**Project #20-057
Stronghold Development
Located at 200 South 1000 West**

Project Name: Stronghold Development
Proponent / Owner: Ironwood Construction / Stronghold Opportunity LLC
Project Address: 200 South 1000 West
Request: Design Review & Conditional Use Permit
Current Zoning: Commercial Services (CS)
Type of Action: Quasi-Judicial
Hearing Date: Nov 12, 2020
Submitted By: Russ Holley, Senior Planner

Staff recommends that the Planning Commission **conditionally approve** a Design Review and Conditional Use Permit for Project #20-057, Stronghold Development, storage units and flex commercial buildings located at approximately 200 South 1000 West, TIN #05-064-0028.

SCHEME F SITE PLAN

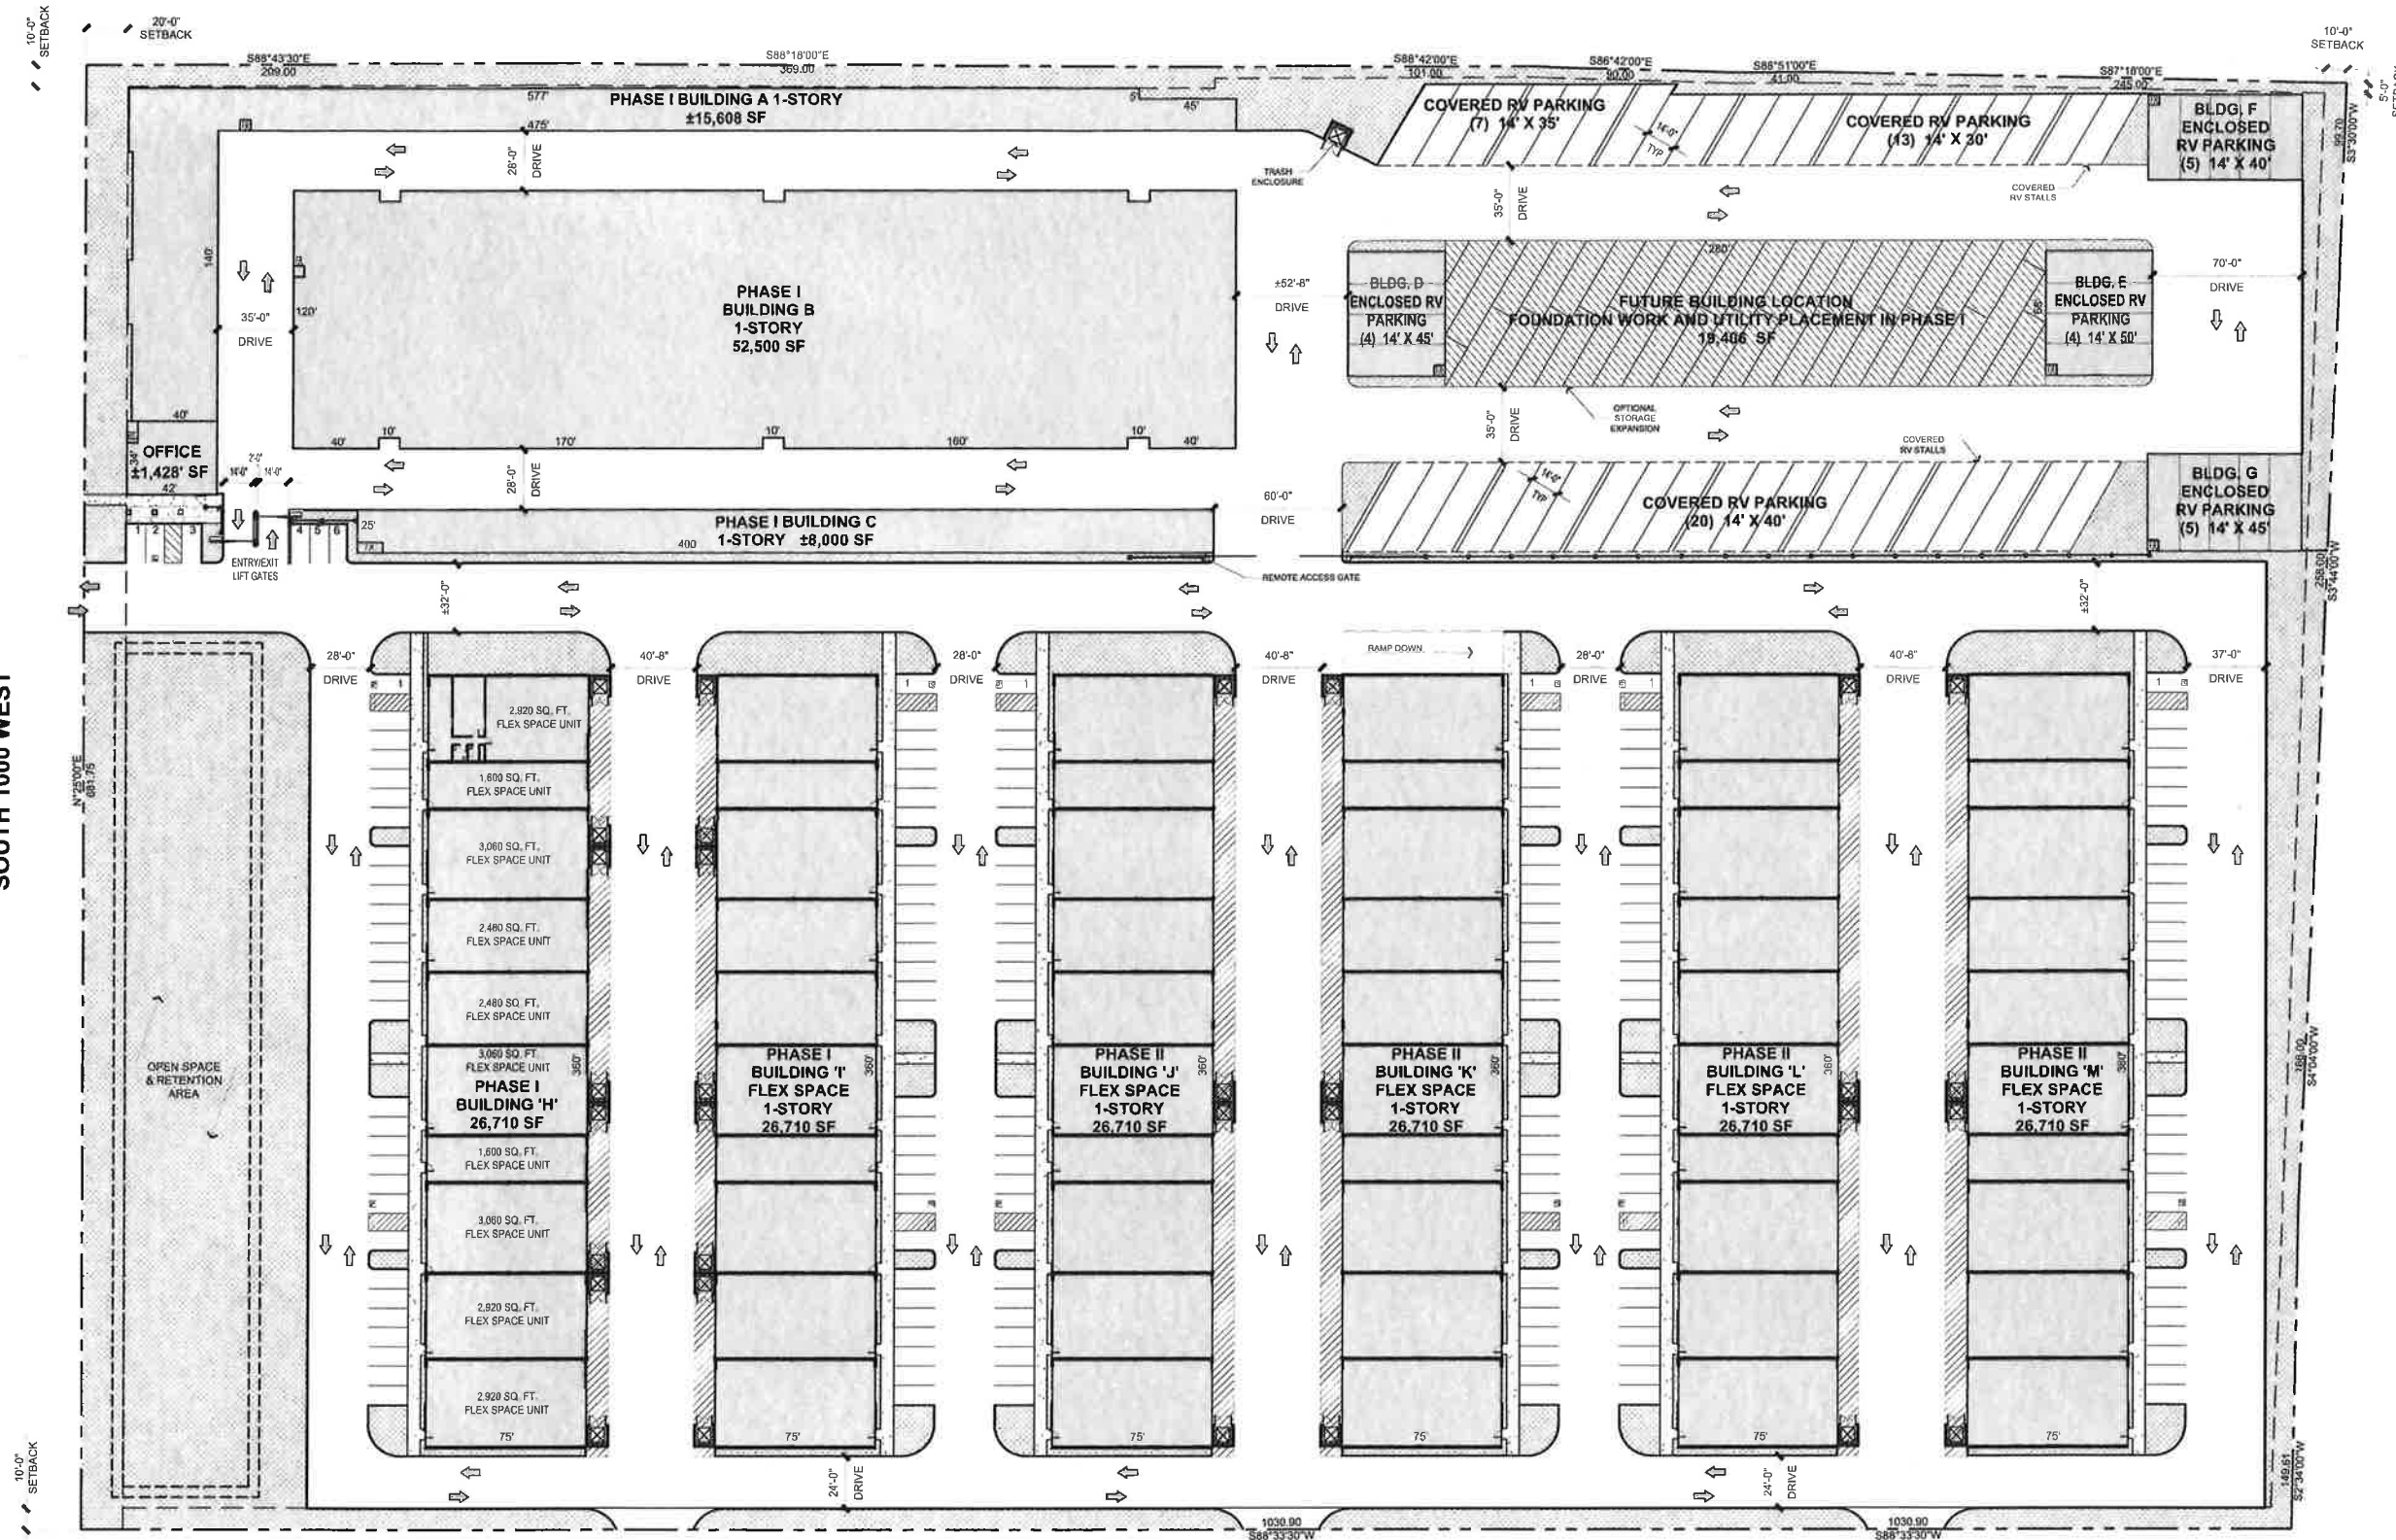
The LDC 17.31.090 requires commercial and industrial sites to include safe and convenient pedestrian circulation from the adjacent streets to buildings, parking areas and other outdoor gathering areas. When parking areas are proposed in areas adjacent to streets, LDC 17.32.070 requires additional landscaping to help screen asphalt parking areas. Type "A" screening is required when a parking lot is 25' from the street. This type of screen requires additional shrubbery and trees in this space for buffering purposes. As conditioned with pedestrian circulation and Type "A" screening, the project complies with the LDC.

The project is shown with four (4) vehicular accesses. One onto 1000 West and three onto 200 South. The one on 1000 West aligns with a driveway across the street, but the three on 200 South do not align with intersections across the street. The project shows only pedestrian circulation in front of the commercial buildings and around the perimeter streets. As conditioned with access refinements, the project meets the access and circulation requirements in the LDC.

4. The single-sided limited parking lot shown between the west commercial building and 1000 West may remain as shown with additional landscaping buffering (Type A) added.

5. A minimum of 193 parking stalls and a bike rack shall be provided for commercial areas. 4 parking stalls shall be provided for the storage units.
6. Pedestrian pathway connections shall be made throughout the site for safe pedestrian circulation.

BLDG. A SOUTH OFFICE ELEVATION ②
1/8"=1'-0"

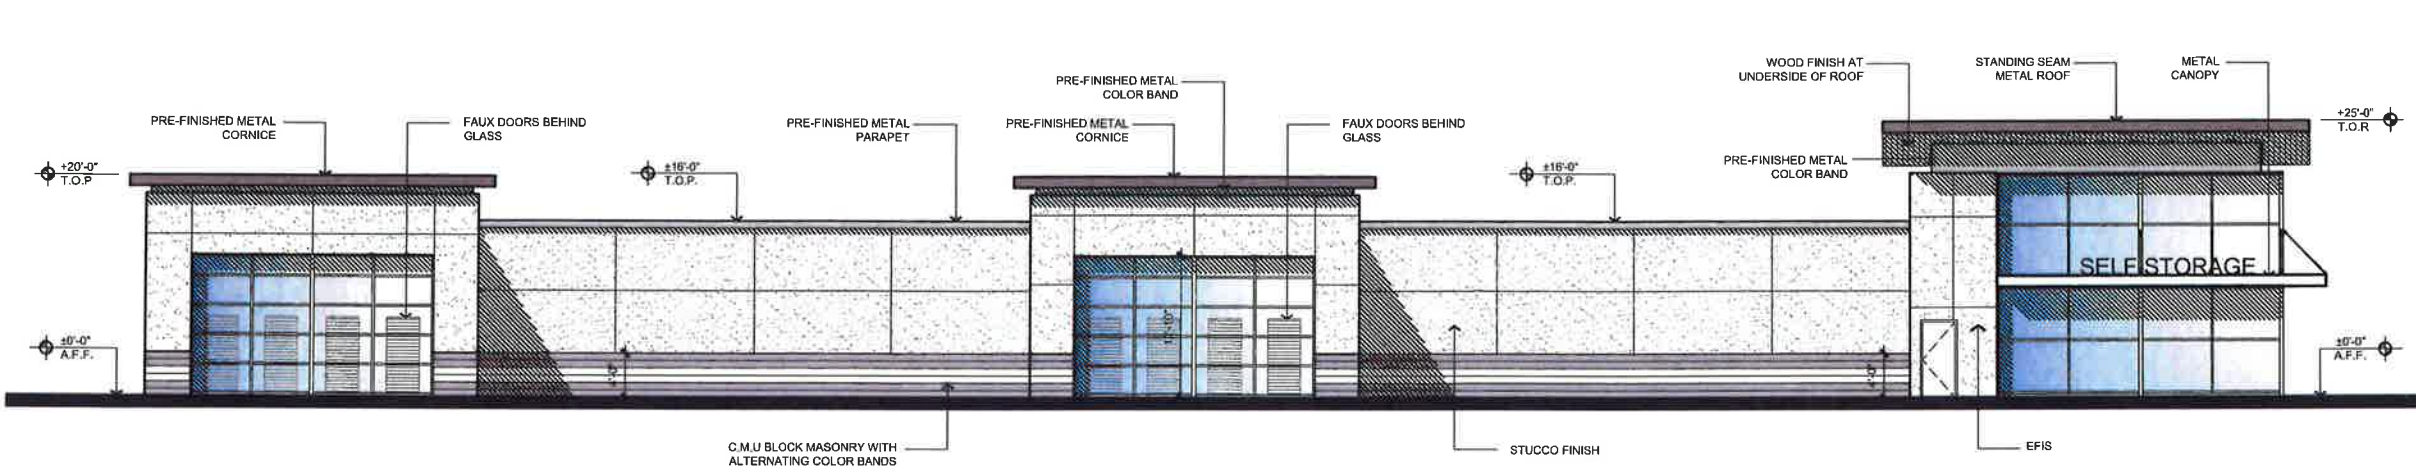
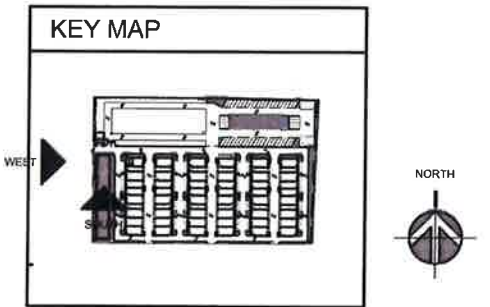
The LDC 17.10.080 states that ground floor frontages and exposed side facades are required to have 30% of the overall façade area as transparent (fenestration). Calculations for the ground floor façade area on the proposed buildings show approximately 15% transparency on the south street facing facades and 30% and west façade. As conditioned with additional south façade transparency, the project meets the requirements in the LDC.

1. All standard conditions of approval will be recorded with the Design Review and are available in the Community Development Department.
2. The street facing (south) facades shall not be the same as the adjacent façade.

3. All street facing facades (south) on the commercial buildings shall contain 30% transparency and similar architectural details found on the parking lot facing facades.
